TITLE: Review and action of a Subdivision Permit and Plat for Bybee-Hixson

Subdivision, a replat of Tracts 100, 101, and 102, HR Ranch, 3rd Filing,

PZ-17-00128 BYBEE-HIXSON SUBDIVISION PERMIT AND PLAT

Attachment 8: Plat

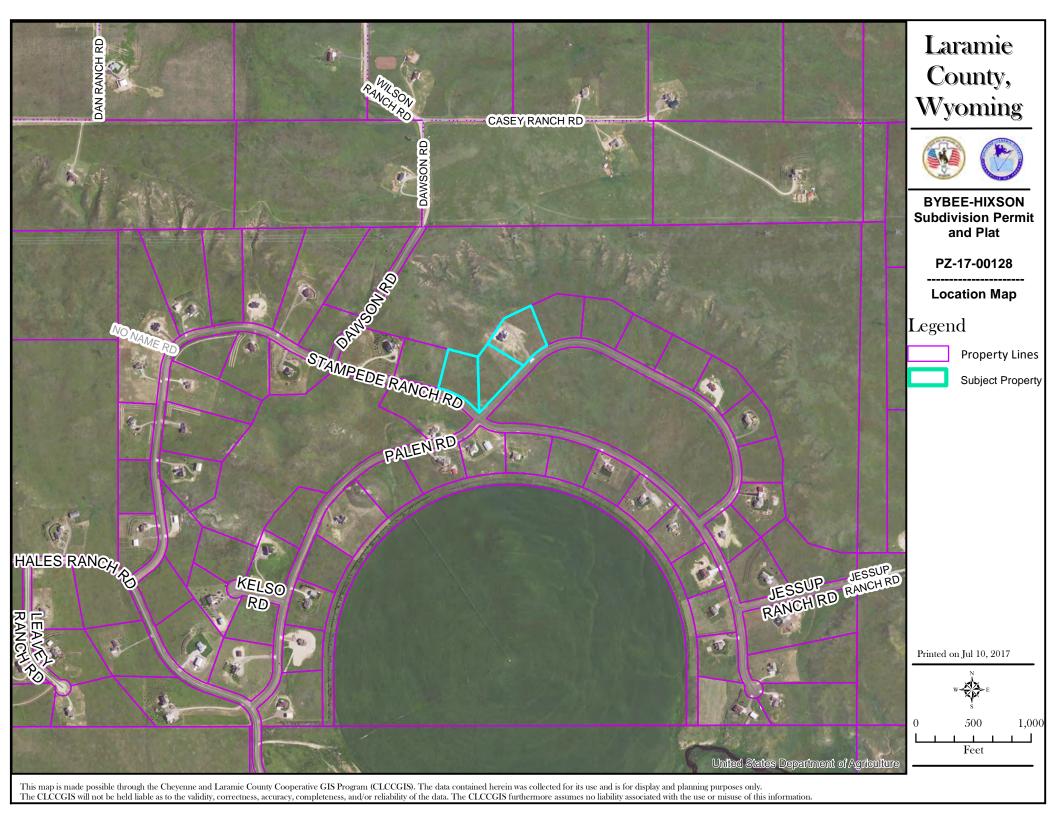
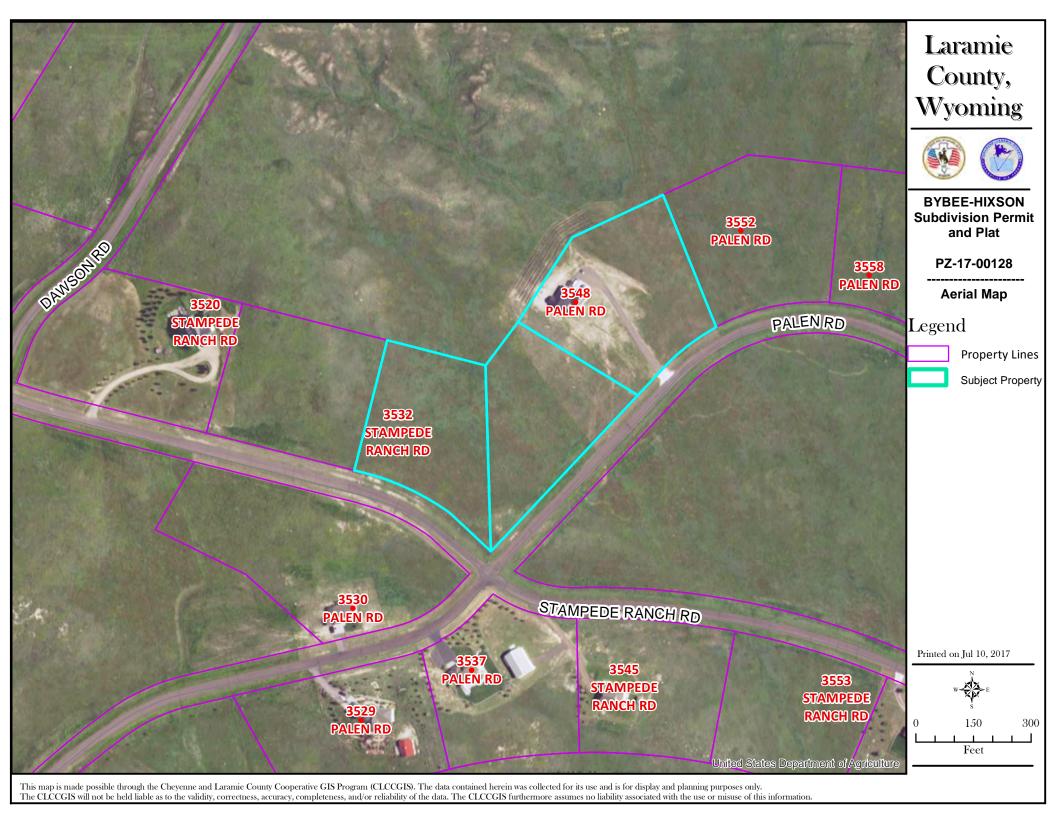
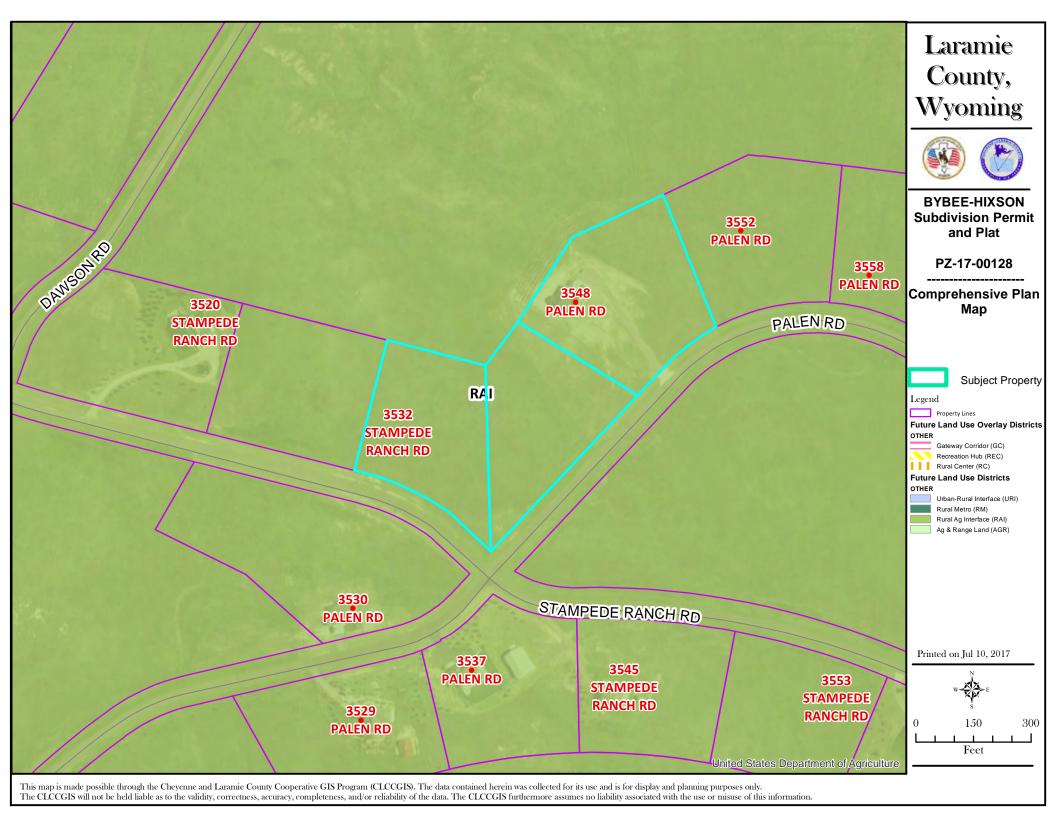
<u>County Assessor:</u> Clarice Blanton COMMENTS ATTACHED 07/12/2017 Unless otherwise noted HR Land Company will be listed as joint owner in Tract 100A and Tract 102A.

The Title Block usually appears in the lower right corner. It should read more like:

BYBEE-HIXSON SUBDIVISION A re-plat of Tracts 100, 101 and 102 HR Ranch 3rd Filing NW 1/4, Sec 36, T14N, R65W.....

If the re-plat information is not included Real Estate will most likely not record the plat.

County Real Estate Office: Debbie Valdez-Ortiz COMMENTS ATTACHED 07/11/2017 The title block should be in the lower right corner of the Plat. It needs to have the subdivision name and tracts listed that new Plat comes out of not just the T-R-S that HR Ranch Third Filing came out of. In Notary for Paul Lowham it needs to state HR Land Co. In the Notary for Wes Bybee his last name is spelled as Mybee. And unless all three are going to share ownership of the two lots it should state who is keeping what tract.

- 1. A note regarding whether or not any portion of this plat falls within a FEMA flood hazard area and reference to the FIRM Panel Number needs to be included on the plat drawing.

- 2. A note stating which fire district will serve this subdivision needs to be added to the plat.
- 3. I concur with the request for a waiver of a detailed Traffic Study and Drainage Study since the proposed action will not increase either the traffic or the drainage/runoff. Surveyor Review

- 1. Plat requirements state "name of the subdivision shall be placed in the lower right hand corner of the plat." The name of the subdivision appears in the upper right hand corner and in the side-bar title block. The side-bar type of title block may not be the best solution for subdivision plats.

- 2. In the last line of the first phrase of the legal description, "and the intersection" should be "at the intersection".
- 3. In 14th phrase of the legal description -- bearing stated as "SOUTH 43°13'58" should be "SOUTH 43°13'58" WEST".

- 4. In the last line of the Statement following the legal description, should "THE PURPOSED" be "THE PURPOSE"?
- 5. BYBEE ACKNOWLEDGEMENT "ACKNOWLEDGED BEFORE ME BY WES M. MYBEE (should be BYBEE)"

- 6. LOWHAM ACKNOWLEDGEMENT Is there a reason for the extra blank signature

line preceding 'PAUL LOWHAM'?

- 7. Plats require the date of plat preparation be included. Does the date shown on the side-bar title block (06/26/17) signify the date of plat preparation?

- 8. On the "Approvals", the signature block currently shows "Development Director" but it should be "Chairman of the Planning Commission".
- 9. Plat requirements state that "For subdivisions in the County, survey tie(s) by bearing/azimuth and the distance to the nearest public land survey system monument shall be accurately described on the plat." This item ix is not addressed on the Plat.

- 10. Plat requirements state "The Basis of Bearing/Azimuth on which the survey is based shall be noted on the plat". No Bearing Basis Is shown on the plat.

- 11. Statement to Vacate requirements state "If any lot, block, boundary or right-of-way from a previously recorded plat is being vacated by this plat a notation shall be provided, describing the area or boundaries to be vacated under a section titled Statement to Vacate." Although there is discussion of vacating Tracts 100,101, and 102 of HR Ranch 3rd Filing in the dedication, there is no "Statement to Vacate" on the plat.

- 12. Plat layout shall include the following: C. "The location and dimensions, with boundary ties, for all existing and proposed utility, drainage, access, or other easements." The drainage easements are not detailed. F. The Vicinity Map would be easier to read and it would be more useful to the lay public if one were to add some information such as, at a minimum, the Section, Township and Range data with enough detail to indicate the location of the subdivision generally within the Section.

- 13. As a final note, I did not see any mention of irrigation water rights on the subdivision so I assume there aren't any on the subdivision. However, there is a center pivot irrigation system adjacent to this subdivision and it might be a good idea to note that there are no water rights on this subdivision, if there aren't any.

Public notice was published and neighbor notice letters were sent by certified mail. No public comment was received. Agency comments regarding clerical errors were addressed with the revised plat submitted on July 31, 2017.
